## TECHNICAL BULLETIN

### COUNTERMEASURE FOR STATIC ELECTRICITY

- 1. Model Name:** FO730, UX310/370/470 All versions
- 2. General:** When a multi-page document is copied or faxed (particularly in a 'dry' environment), a build-up of static electricity may cause the copy to appear black.

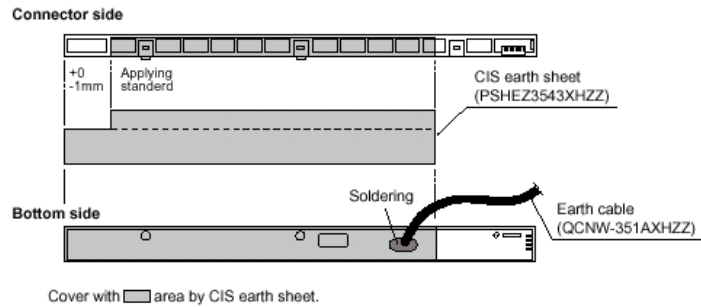
1. Earth the rear roller spindle.  
Earth plate, roller earth cable, and earth gum are added.

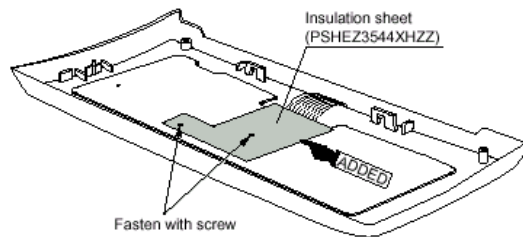
2. Cover the bottom and sides of the CIS main unit with copper sheet and remove the earth.  
CIS earth sheet and earth cable are added.

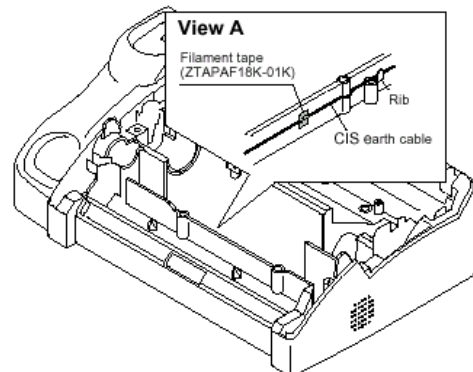
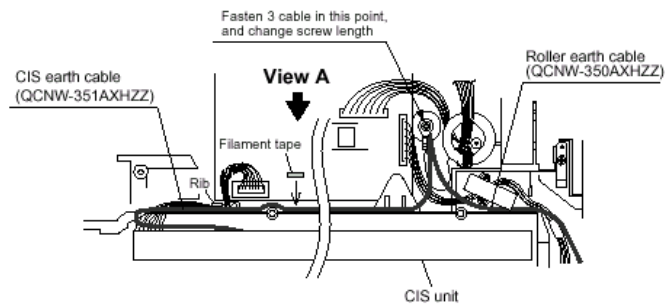
3. Apply insulation sheet to the rear of the panel PWB.
